Accessibility Assessment: Peterborough Transit Terminal

December 5, 2013

Recommendation summary for the main transit terminal building

Recommendation 3: Rework the outer wall of the dispatch area

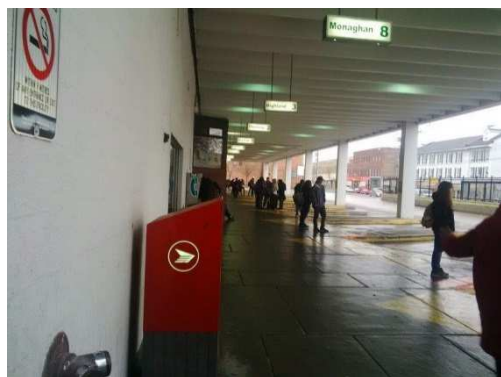
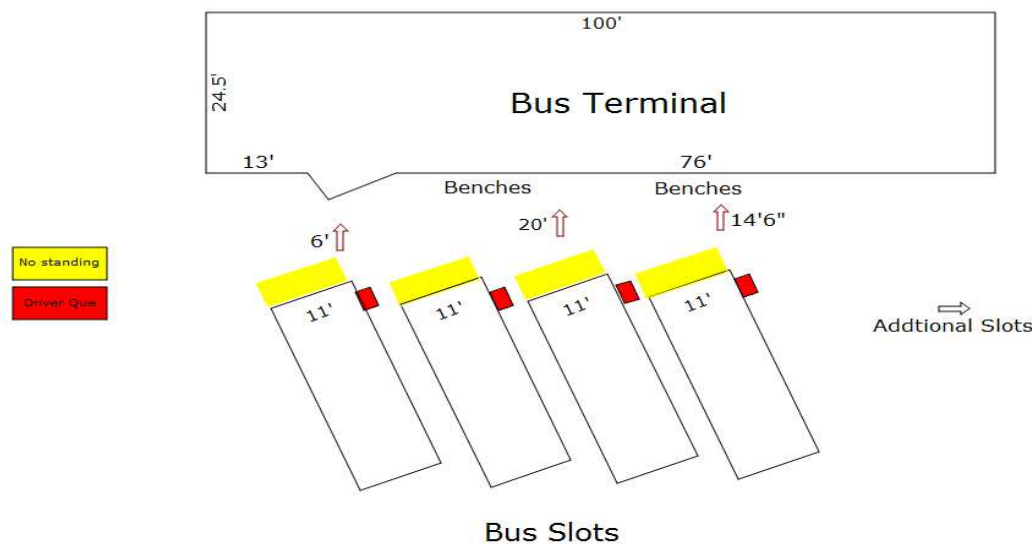
Observation 1: The current dispatch booth protrudes into the platform and reduces overall space for travel on the platform to approximately 4 feet (1219 mm) between the building and the bus parking.

The distance between the bus yellow zone and the terminal is minimal; particularly where the two level section for dispatch juts out.

Remove the portion of the old Dispatch area that juts out into the external platform area so that it is flush with the rest of the building. This should be incorporated into the draft plans should the city undertake a major renovation. This would help to maximize the space for pedestrian traffic along the platform in front of the building and improve accessibility and safety for those using mobility devices that may require more room to maneuver.

Recommendation 5: Upgrade the washrooms

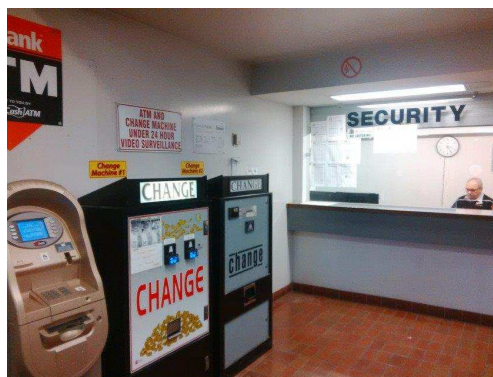
Observation: The current washrooms are not accessible

None of the washrooms are designated as accessible washrooms and each has multiple issues including lack of automatic door openers, grab bars in the stalls and general lack of space for those with mobility devices to maneuver in the washroom.

In the event that no major renovation occurs, there still needs to be a washroom that includes accessible features within the building. For a better understanding of what features to include see the renovation guidelines section below. If this work is done to the public washrooms it can provide access for both staff and public as needed.

Recommendation 6: Accessible customer service and security counters

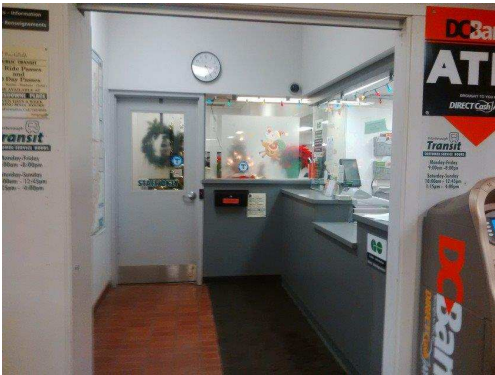
Observation: The ticket counter and security counter lack accessible counter features

Under the proposed new building code service counters need to have a designated accessible section suitable for wheeled mobility devices or persons seated in chairs complete with lowered counters, open space beneath the counter and colour contrasted edging on the counter.

Public Area – Line-up and Queuing

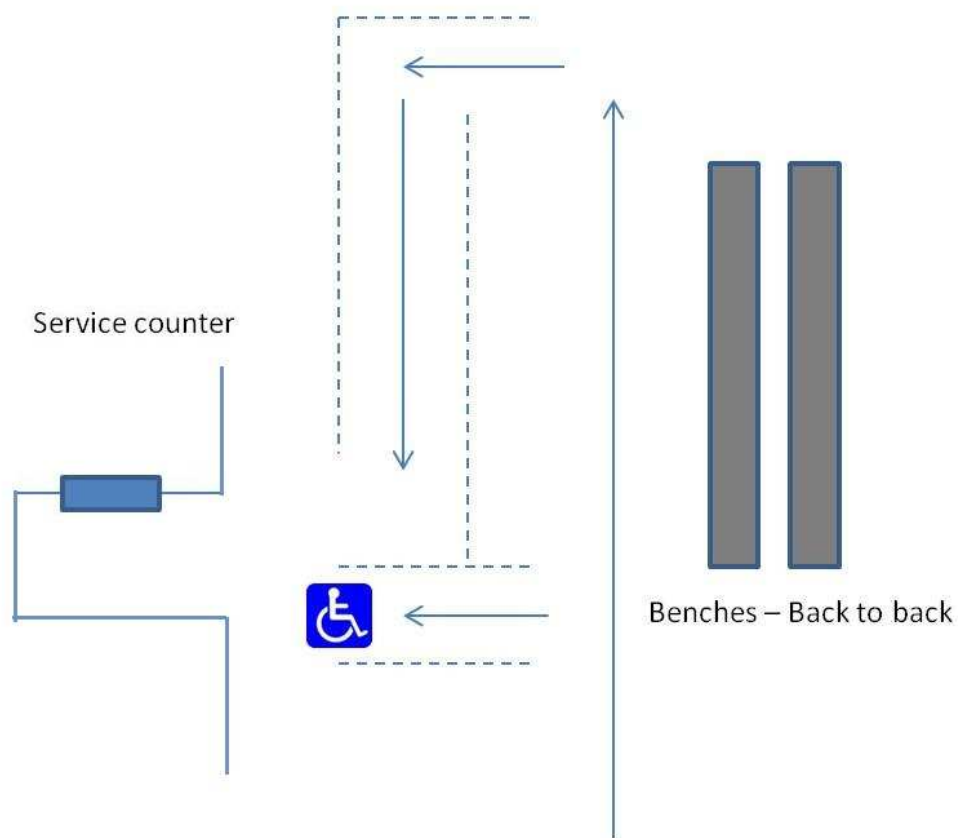
Observation: Usability and Accessibility could be improved for all patrons through queuing lines and signage.

Implement a queuing system for the ticket counter that will ensure an organized pedestrian flow to interact with staff in a more efficient manner. This system should provide for more easy direct access for those with disabilities

Recommendation 2: Make surface repairs to the external platform area

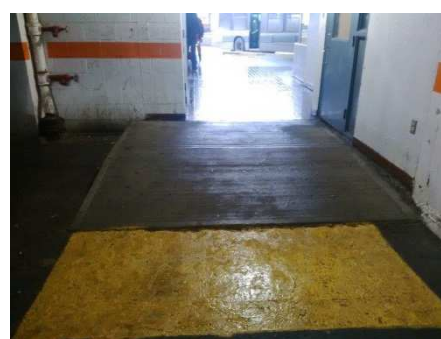
Observation: The surface has cracks and holes which are trip hazards at various points along the loading zones

Observation: The loading zones lack non-visual cues to assist those with vision impairment

Observation: The ramp from the parking garage to access the terminal is uneven and changes surface four times within 25 feet (7620 mm) which creates a slip fall contrast hazard for people with visual disabilities.

There are specific slip/fall hazards that should be addressed for the safety of the general public. We would recommend several options. Option 1: Repair existing holes in the tile and concrete surfaces. Option 2: Standardize the surface by replacing the tiled area with concrete. Option 3: Apply a non-slip substance to the tiled areas specifically to reduce the risk of slip/fall. Option 4: Specific to those with visual disabilities, incorporate tactile surfaces to indicate queuing areas and danger areas around where busses park. It is further recommended to consider standardizing the walkway from the external platform area to the city parking garage to eliminate the issue with uneven surfaces and inconsistent surface textures.

Recommendation 3: Make changes to the Accessible Parking

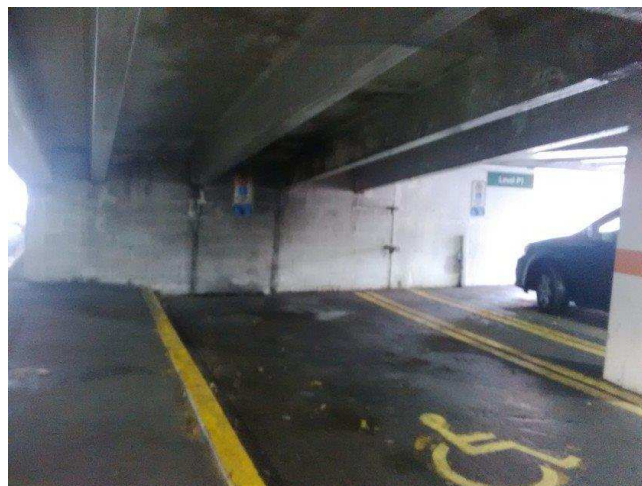
Observation: 3 of the 7 designated accessible parking spots are potentially unusable by those with special needs and do not meet the proposed Built Environment Standard recommendations.

Of the seven, two are in questionable locations that could hinder use of the parking spots due to a low overhang and physical proximity to a raised curb, and one is virtually unusable due to the location adjacent to a pillar and a raised curb with no curb cut.

The three designated Accessible parking spaces that are located under the city garage ramp should be relocated to the central location where the other four are located or alternately in the outside lot in order to make sure that all the Accessible parking spaces are usable. The spaces should be repainted and sized to provide a mixture of Type A – Mobility Aided and Type B – Distance Limited spaces in accordance with the proposed built environment standard regulations. We also recommend designating one of the spots on the east side of the terminal as an accessible vehicle drop off spot to provide safe easy access to the terminal.

Recommendation 5: Upgrade the city parking garage stairwell

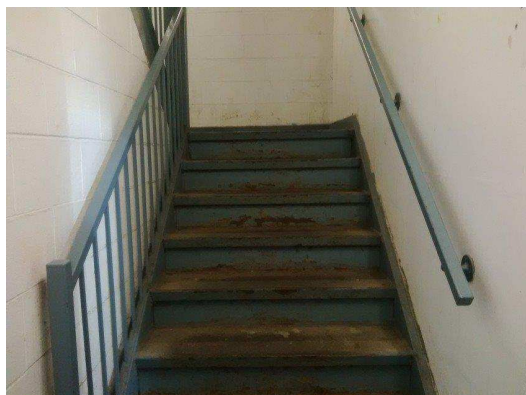
Observation: The railing is not at the correct height.

Observation: The stairs lack proper edge strips.

Observation: The ground level fire extinguisher in the stairwell is not properly secured in place.

There is no signage in the stairwell to indicate which floor you're on. The stairs do not have edge strips as outlined in the proposed built environment standard.

The stair access to the transit terminal from the City Parking garage needs to be addressed as it poses a safety risk to the public. Further, any improvements considered should specifically be undertaken to meet the proposed draft Built Environment Standard. Specifically, the handrails need to be raised to a minimum of 34 inches (864 mm) high. The front edge of the individual stairs need to be upgraded to include edge strips that extend the full width of the tread and provide a tonal contrast with the rest of the tread to provide visual cues as to the edge of the stairs. We recommend the edge strips be of the variety that provide a textured grip strip and a photo-luminescent colour strip which meets the colour difference requirement for stair edges and also aids in emergency evacuation situations by helping people exit the building safely even if the lighting systems fail. Finally, the fire station needs to be repaired to ensure the fire extinguisher in the stairwell is accessible yet secured in place.
